COMPRESSOR REMANUFACTURING / REBUILDING MANUAL

SECTION	5	TABLES OF GENERAL INFORMATION
SUB SECTION	D	BULLETINS OF CHANGES OR MODIFICATIONS
	D.3	COPELAND
		INDEX OF BULLETINS IN THIS SECTION

SECTION	5	TABLES OF GENERAL INFORMATION
SUB SECTION	D	BULLETINS OF CHANGES AND MODIFICATIONS
	D.3	COPELAND BULLETINS
	3.a	4R and 6R continuity

LARGE OIL SUMPS

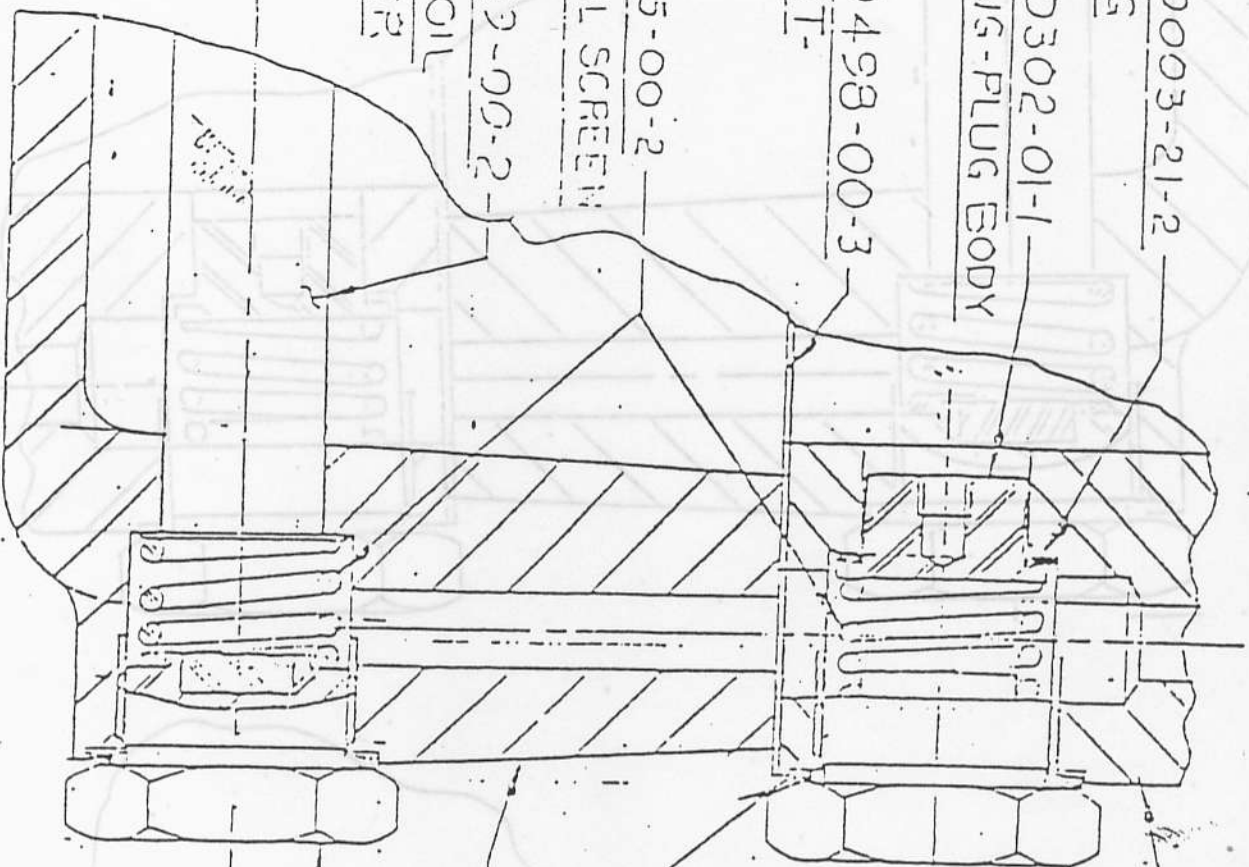
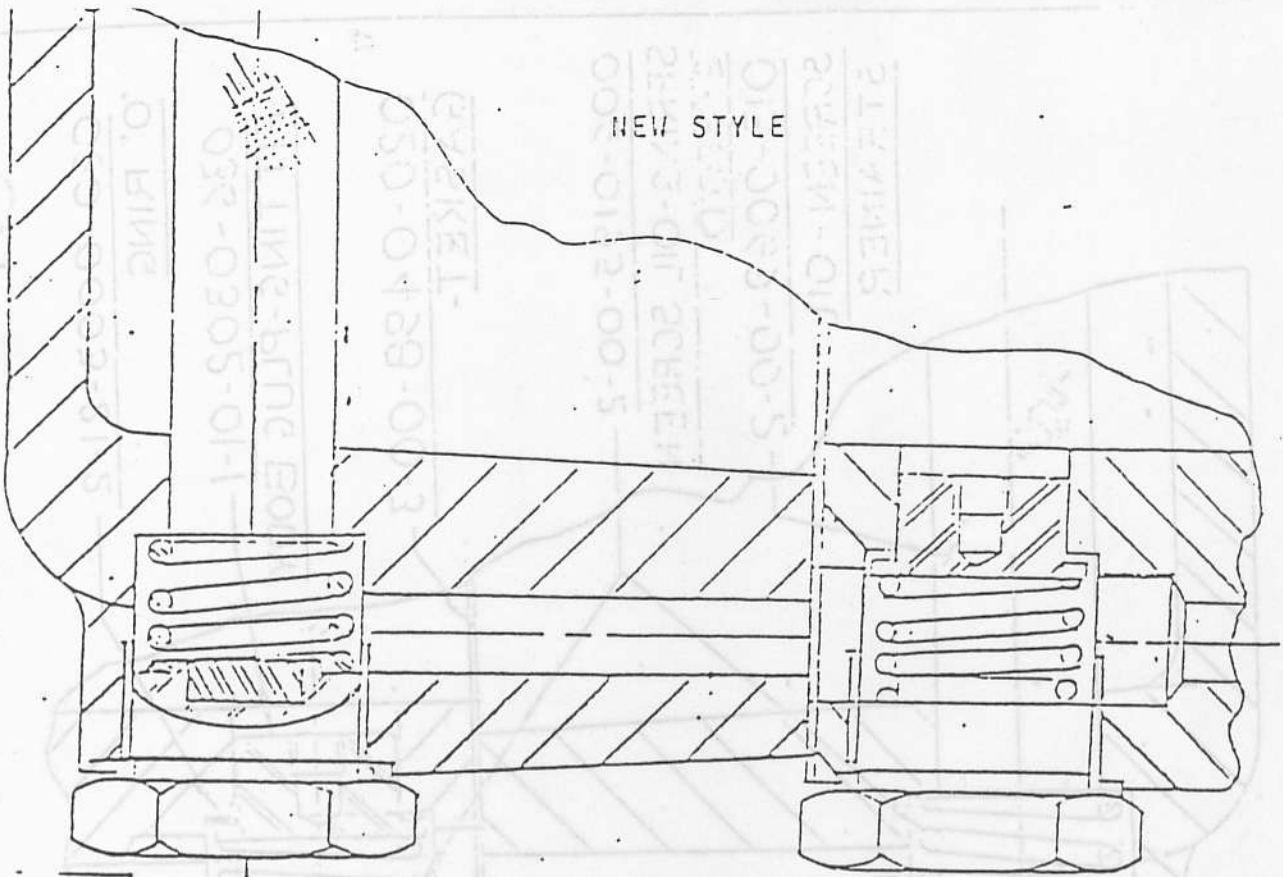
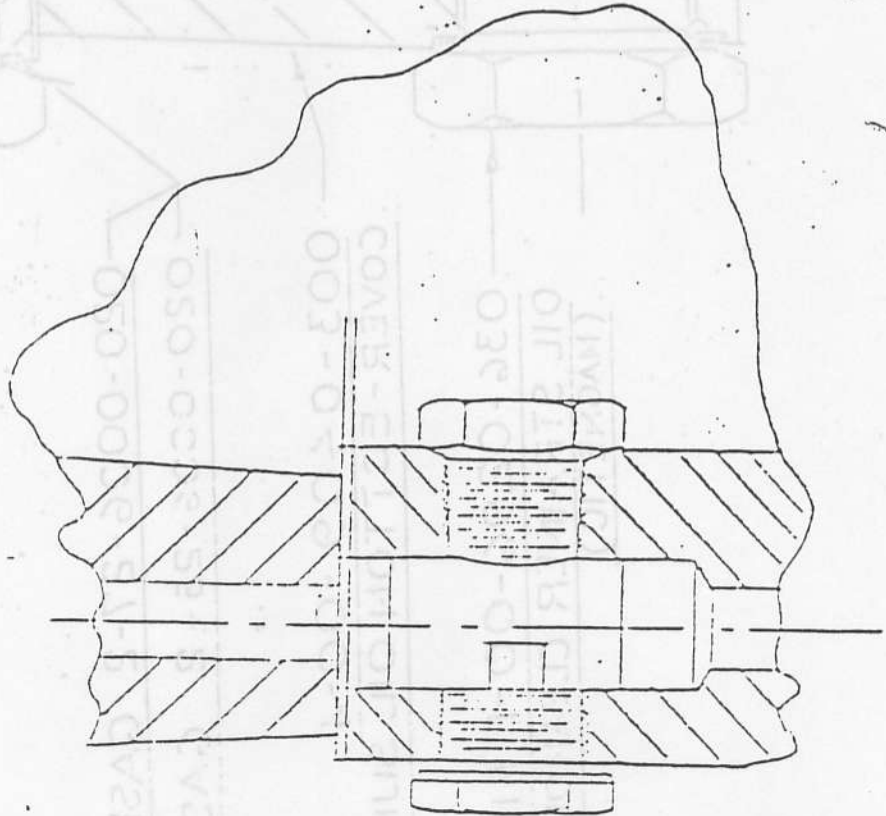
Models 4RA5, 4RH5, 6RA5 and 6RH5 have the large oil sump, 4RA, 4RH, - 6RA & 6RH models can be converted to the dash 5 models, by replacing the bottom plate with the oil sump assembly part no. 998-1314-00.

If the compressor body is machined for a threaded type oil screen installed internally, then a pipe plug must be used to plug this port.

See attached drawings for further information.

SECTION	5	TABLES OF GENERAL INFORMATION
SUB SECTION	D	BULLETINS OF CHANGES AND MODIFICATIONS
	D.3	COPELAND
	3.n	ROTOR LOCKING DEVICES

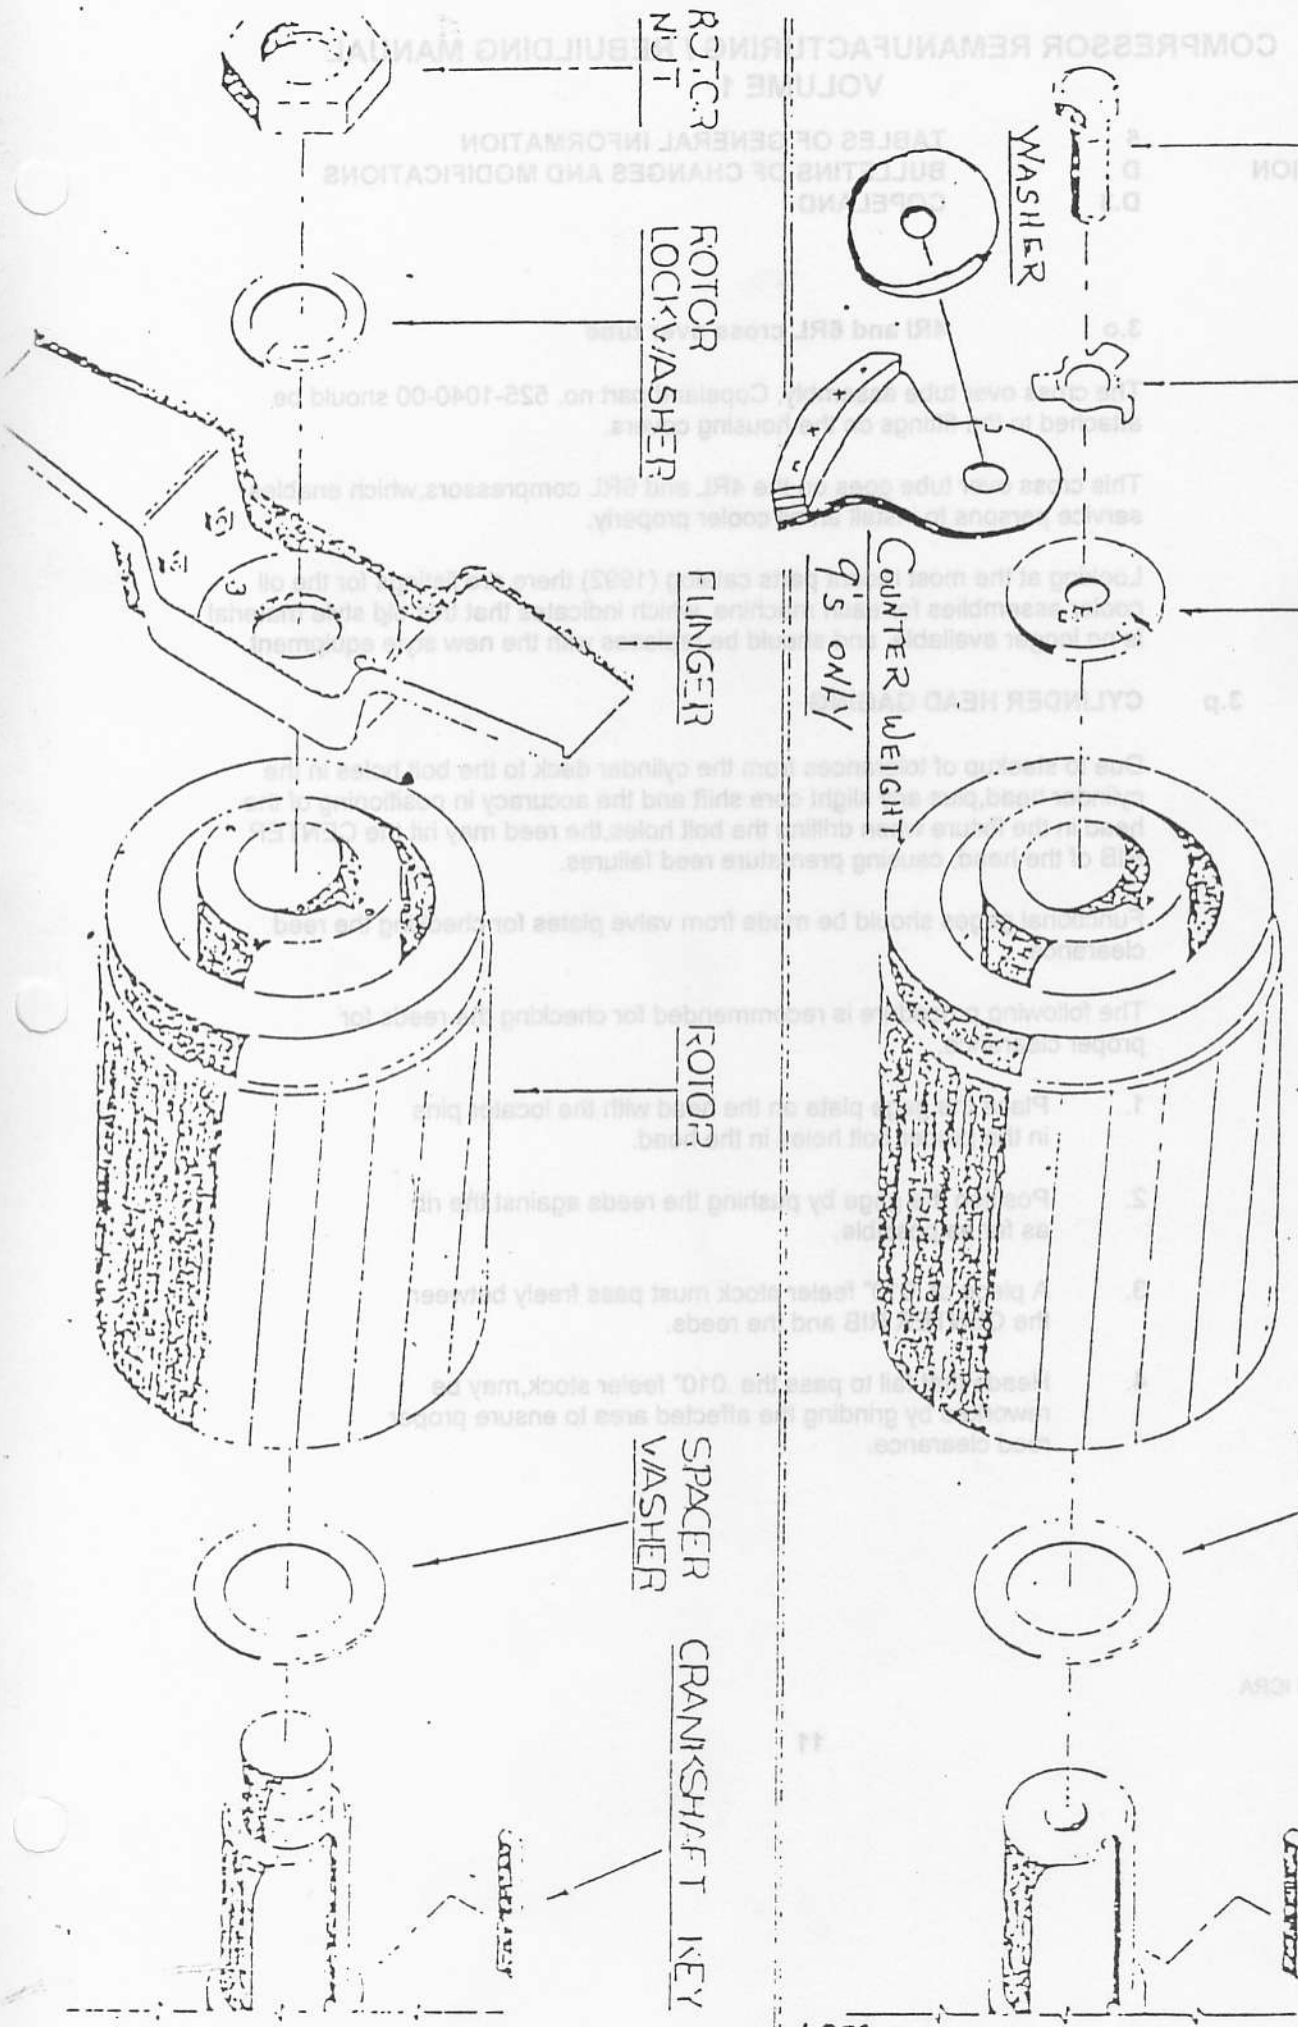
Rotor spacer washers must be used as set forth below in order to provide a positive stop when using rotors with a large chamber. these rotors tend to work over the shoulder of the shaft which results in a loose rotor locking device.

Note 1: Rotor washer part # 102-0047-02 and 102-0047-03 can be used with tang outward or removed if there is interference.

3.r CHECK VALVE FOR 4R AND 6R COMPRESSORS

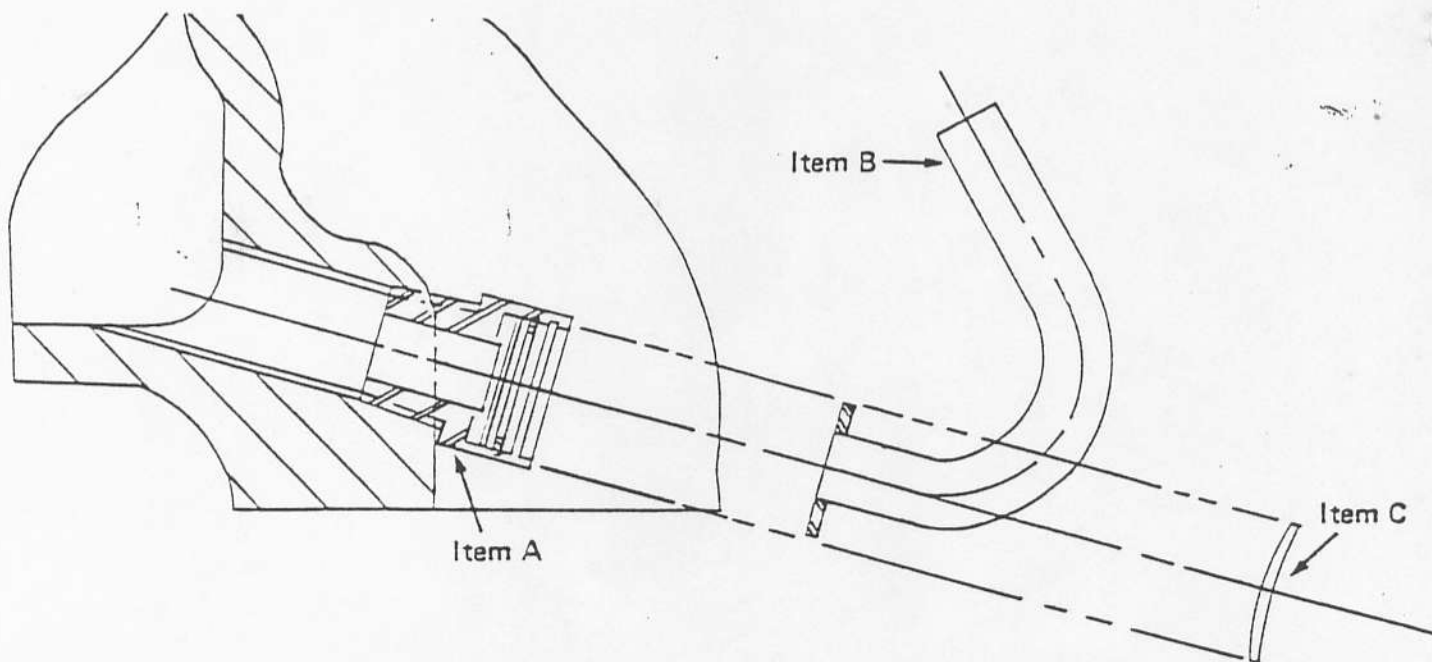
- r.1 Prior to 1965, Copeland 4R and 6R compressors has ball type 1/8-27 NPT oil check valves. Since they introduced the high efficiency valve plates and the thin piston rings in 1979-80, the oil tube was added to the check valve.
- r.2 It is recommended that all 4R and 6R compressors be remanufactured using this later style check valve.
- r.3 Use of the older style check valve may cause the compressor to experience excessive oil carryover rates, and may have an adverse effect on the service life of the compressor.

DIMENSIONAL DIAGRAM FOR 6D SPACER PLATES

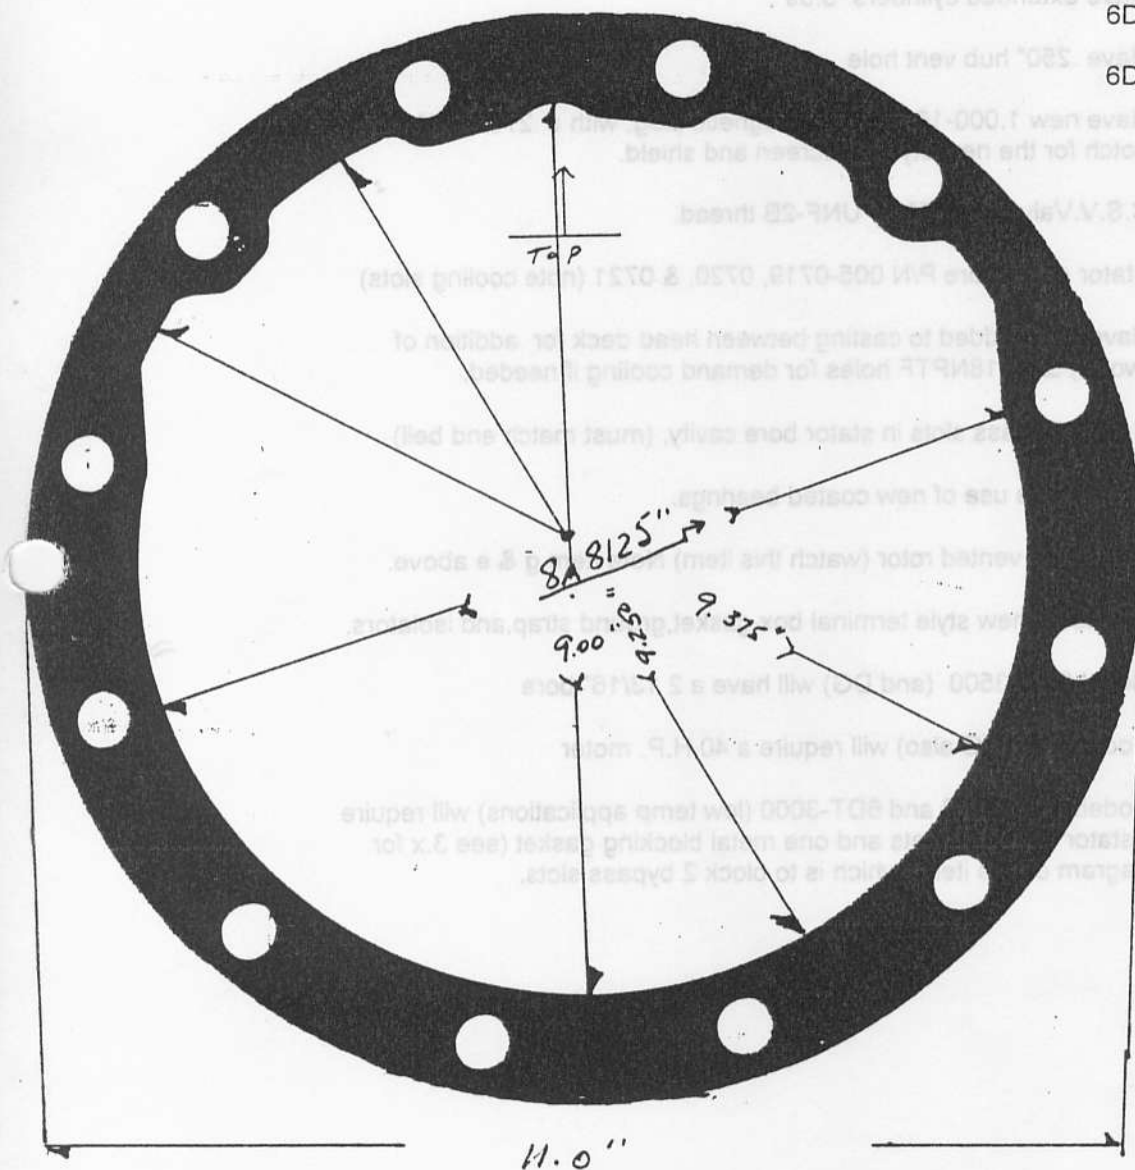
- m. Models 6DL-2700 and 6DT-3000 (low temp applications) will require 2 stator cover gaskets and one metal blocking gasket (see 3.x for diagram of this item) which is to block 2 bypass slots.

LOW SIDE PRESSURE RELIEF VALVE INSTALLATION INSTRUCTIONS

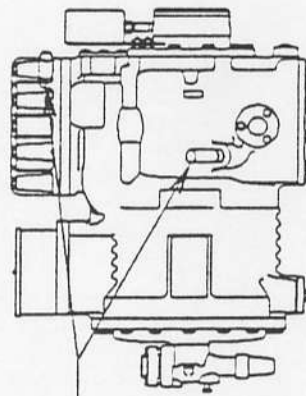
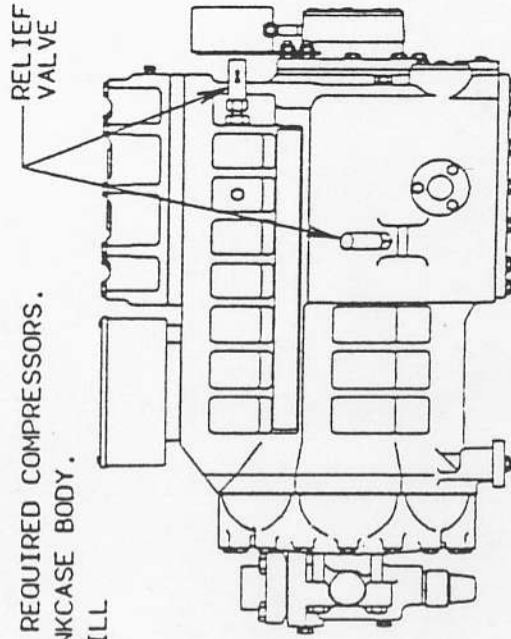
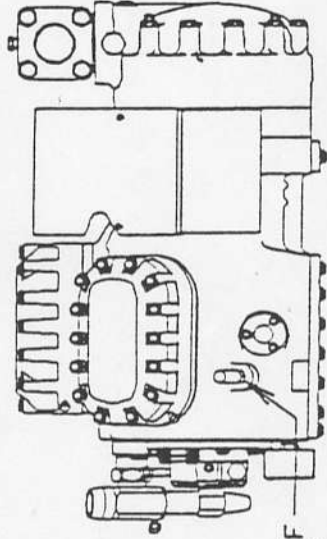
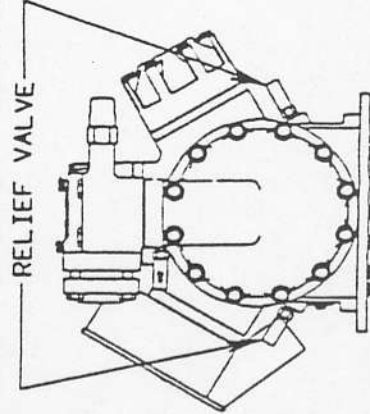
THIS KIT IS SUPPLIED WITH ADAPTERS TO ALLOW FOR INSTALLATION ON ALL REQUIRED COMPRESSORS. H & K MODELS- INSTALL RELIEF VALVE DIRECTLY TO OIL FILL HOLE ON CRANKCASE BODY. ALL OTHER MODELS- RELIEF VALVE CAN BE INSTALLED ON EITHER THE OIL FILL HOLE OR EITHER THE HEAD OR BODY. SEE DRAWINGS DEPICTING THE VARIOUS MOUNTING OPTIONS FOR THE PARTICULAR MODEL IN QUESTION.

WHEN INSTALLING THE VALVE, A PROPER THREAD SEALANT SUCH AS TEFLON® TAPE IS RECOMMENDED TO PREVENT LEAKS. THE VALVE SHOULD BE TORQUED TO,

- 1/8 NPT VALVE - 11 TO 14 FT-LBS
- 1/4 NPT FITTING- 16 TO 20 FT-LBS
- 1/2 NPT FITTING- 36 TO 43 FT-LBS

Figure 1

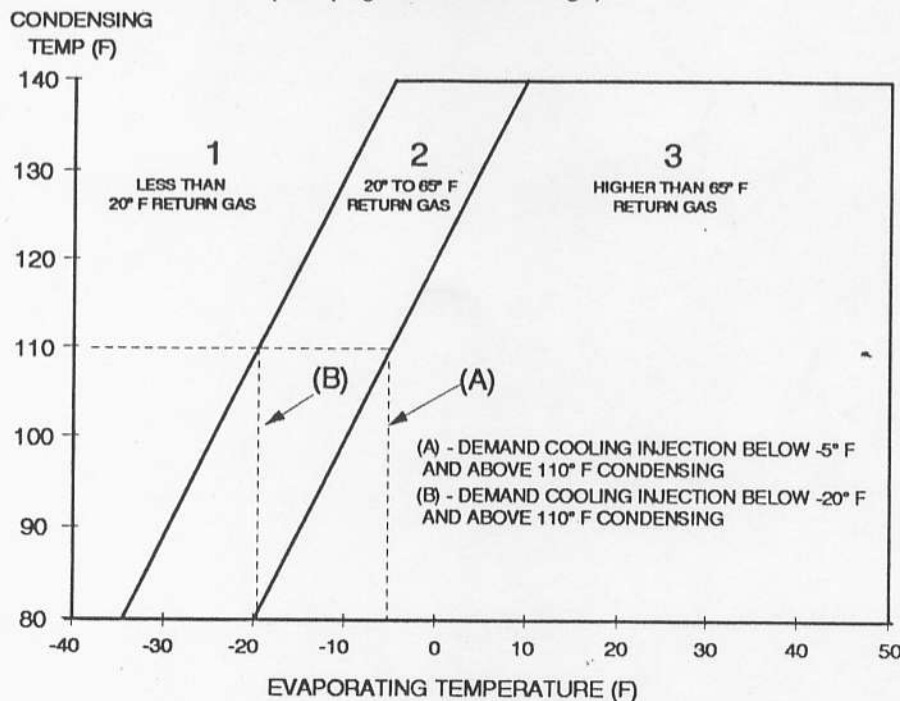
Use **Figure 1** to check Demand Cooling operating areas. **Figure 1** shows where injection begins for two return gas temperatures (65°F and 20°F). The arrows marked (A) and (B) on the graph show the lowest allowable evaporating temperatures, using as an example 110°F condensing temperature.

Point (A) shows that with 65°F return gas and 110°F condensing temperature, the lowest evaporating without Demand Cooling injection is -5°F. Point (B) shows that if the return gas temperature can be lowered to 20°F, while still at a condensing temperature of 110°F, the evaporating temperature may be lowered to -20°F without Demand Cooling operation.

Your injection point can be approximated by drawing a line representing your return gas temperature in between and parallel to the two return gas temperatures on the graph (Area 2). The higher your return gas temperature is, the closer it will be to the "65° line". The lower it is, the closer it will be to the "20° line". You can then draw your own dotted lines representing your condensing and evaporating temperatures to see if you are in the in a Demand Cooling injection zone.
